STAFF RECOMMENDATION
119 Blackburn Avenue
May 16, 2012

Application: New construction—addition
District: Belle Meade Links Triangle Neighborhood Conservation Zoning Overlay
Council District: 23
Map and Parcel Number: 13001018100
Applicant: James Fentress, Architect
Project Lead: Melissa Baldock, melissa.baldock@nashville.gov

Main Level

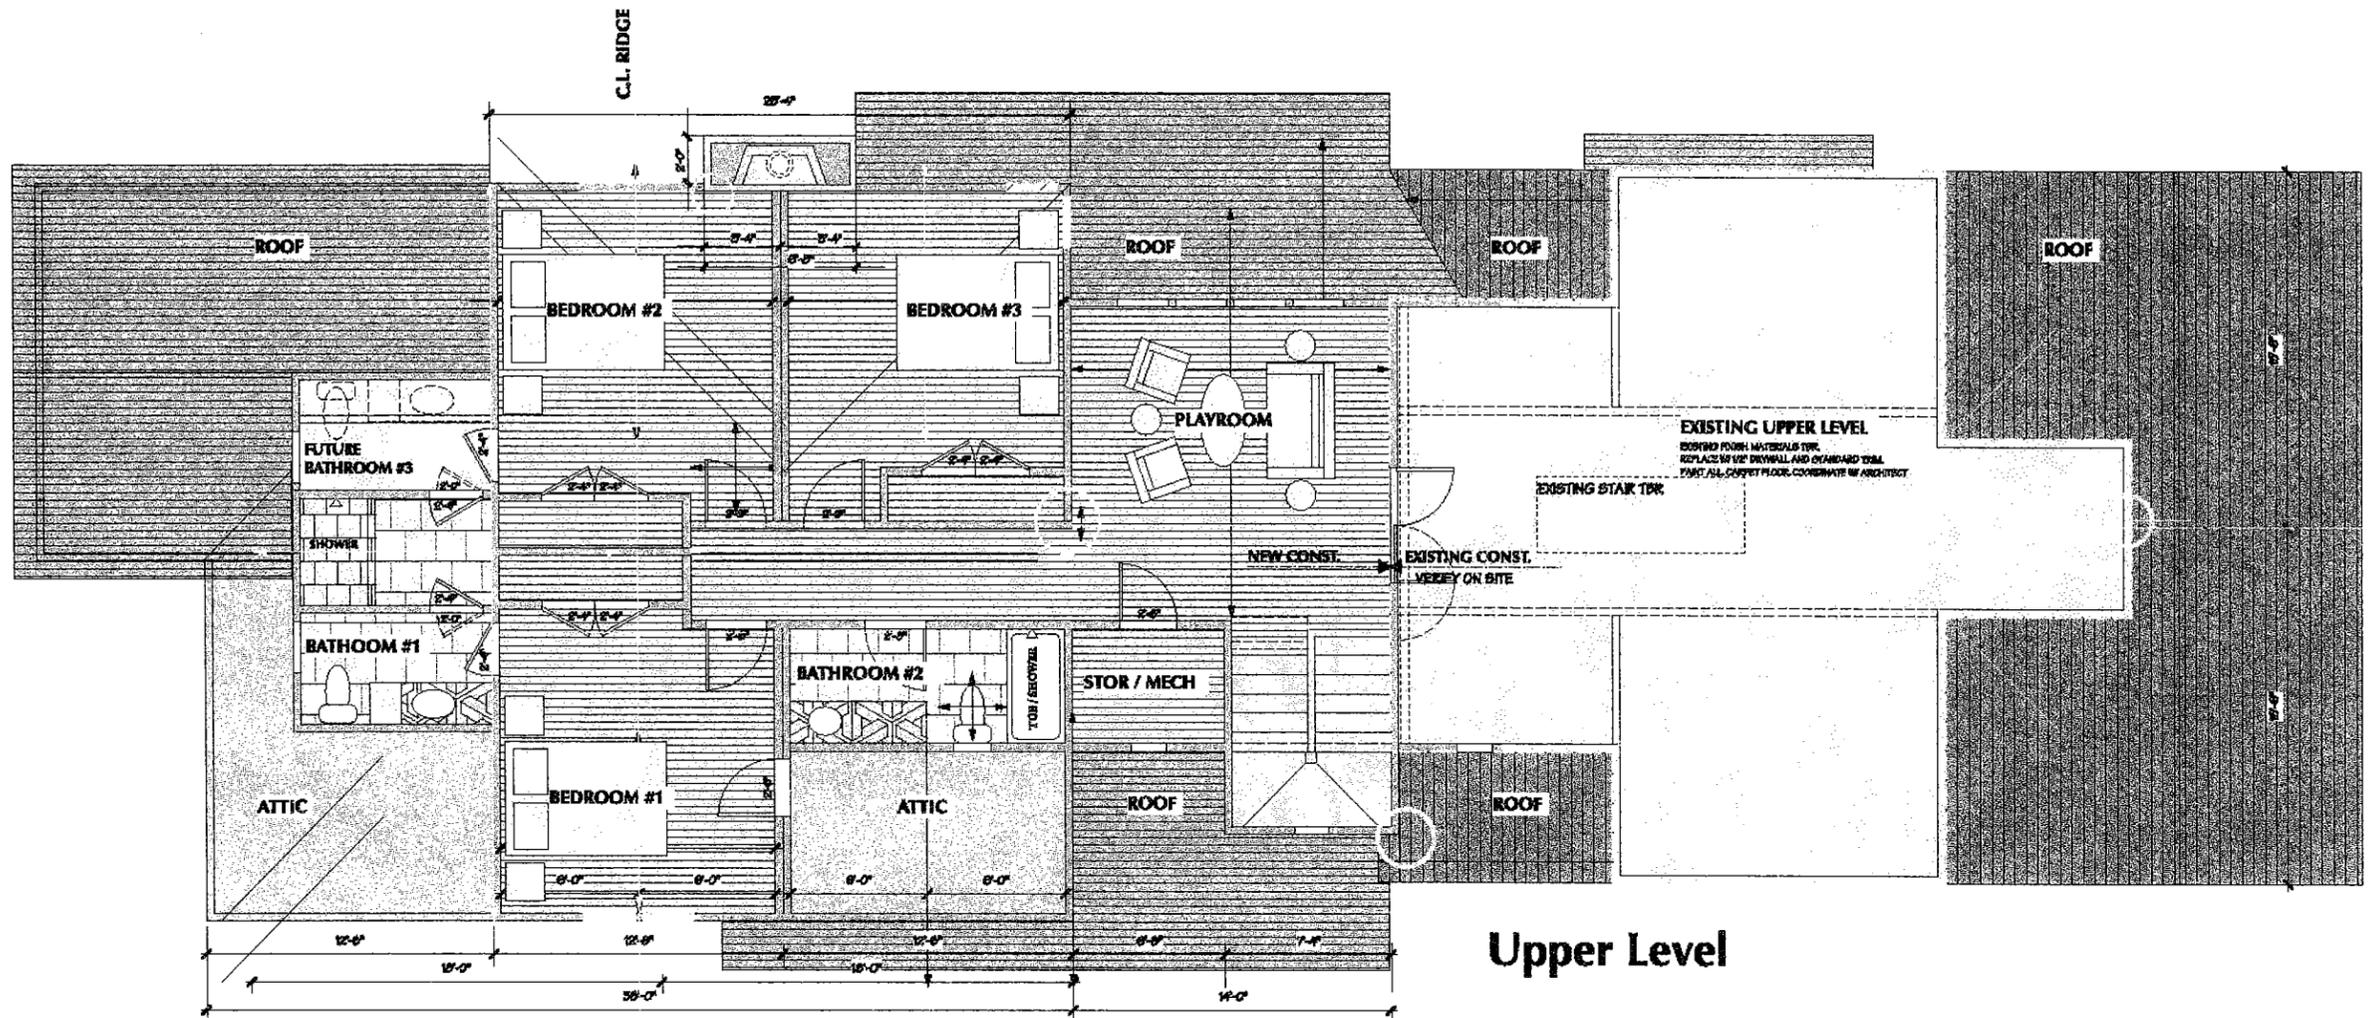
The maximum width of the proposed addition is thirty-six feet (36') and the maximum depth of the addition is fifty-nine feet, four inches (59'4"). At the back of the historic house, the addition steps in two feet (2') from both the left and the right sidewalls for a length of about fourteen feet (14'). After this alcove, the addition on the right side steps back out to line up with the width of the dining room/wider section of the existing house for a length of approximately sixteen feet (16'). After that, the addition steps in two feet (2') for the remainder of its depth. On the right side, the addition is not wider than the historic house.

On the left side, after the alcove, the addition steps out approximately five feet, five inches (5'5") for a depth of approximately fourteen feet, eight inches (14'8"). This portion of the addition therefore extends approximately three feet, five inches (3'5") beyond the left sidewall of the existing house. The addition then steps in approximately one foot, eight inches (1'8") for the remaining twenty-three feet, four inches (23'4") of the addition. This back portion of the addition extends approximately one foot, nine inches (1'9") beyond the left sidewall of the house.

Staff does not believe the proposed width of the addition meets the design guidelines. The Commission typically only approves additions that are wider than the existing house if at least one of the following three conditions are met:

Since none of these conditions have been met, and since the addition is also deeper and taller than the historic house, staff finds that the width of the addition does not meet the design guidelines. Staff recommends that the addition be no wider than the sidewalls of the historic house. The addition on the left side should therefore only step out a maximum of two feet (2') after the alcove.

1. The addition be reduced in width so that it does not extend beyond the sidewalls of the existing house;
2. Staff review and approve the siding material and reveal, the foundation material, a brick sample, the roof material and color, and all window and doors specification prior to the purchase and installation of these materials; and
3. The applicant submit a roof plan indicating the roof pitches so that staff may confirm the appropriateness of the roof forms.

Foundation Plan

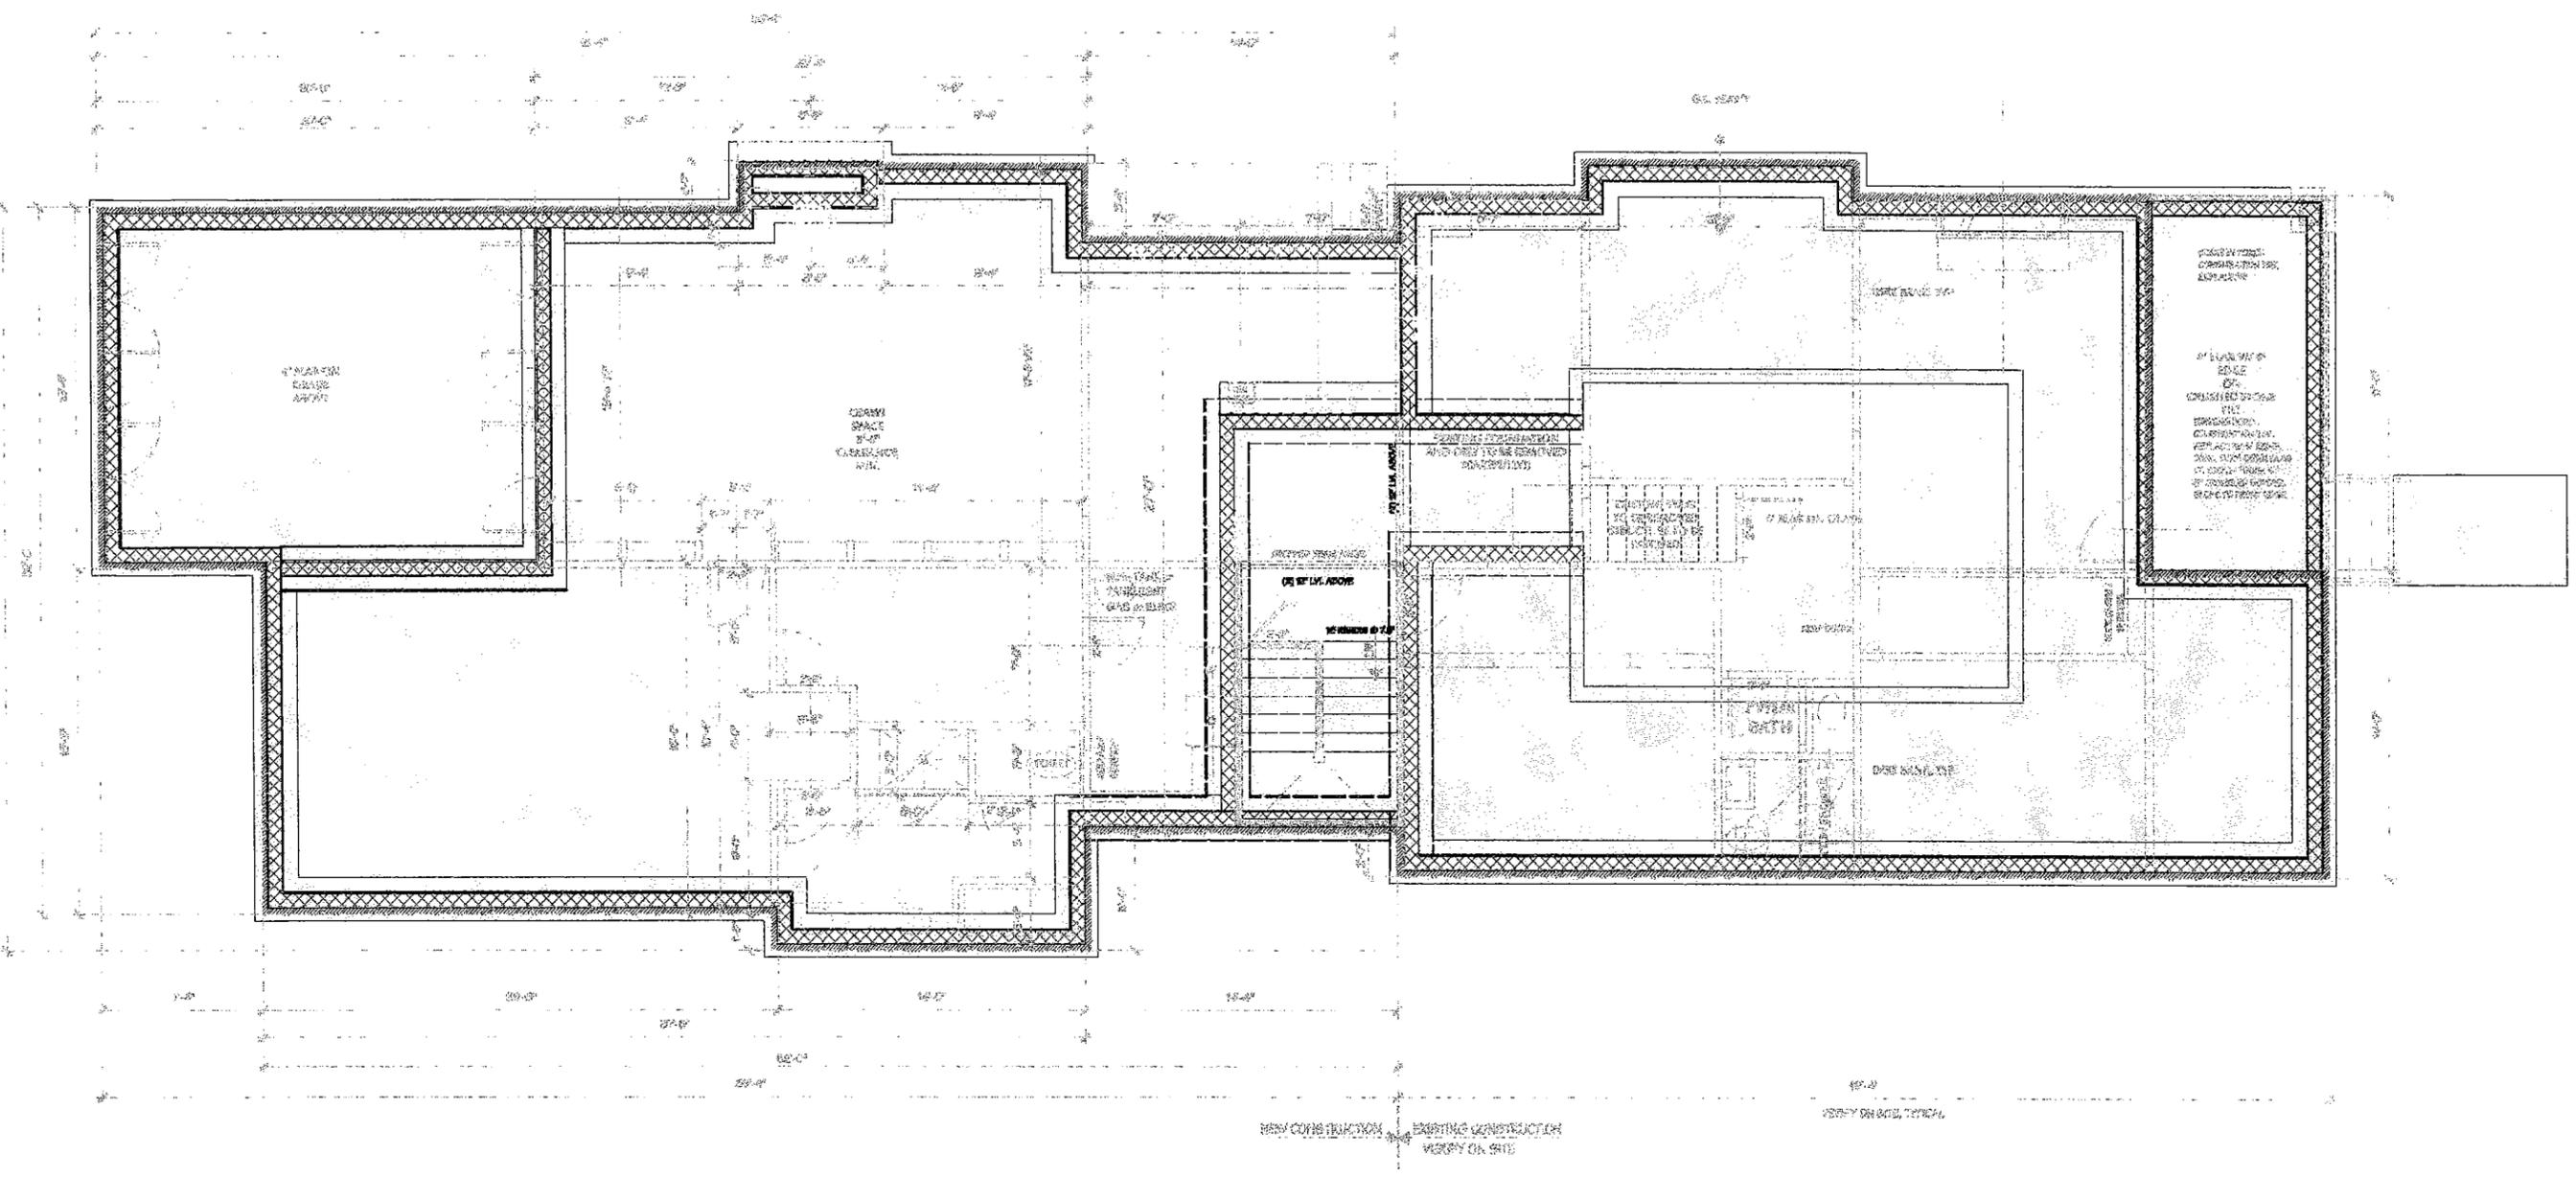
Location & Setback: The proposed meets all required base zoning setbacks. It is located behind the existing house, but does extend beyond the left sidewall of the house. As discussed above, staff asks that the addition be located entirely behind the historic house. With the condition that the addition not be wider than the historic house, staff finds that the location and setbacks for the proposed addition meet sections II.B.1.c. and II.B.2.a. of the *Belle Meade Triangle Links Neighborhood Conservation Zoning Overlay: Handbook and Design Guidelines*.
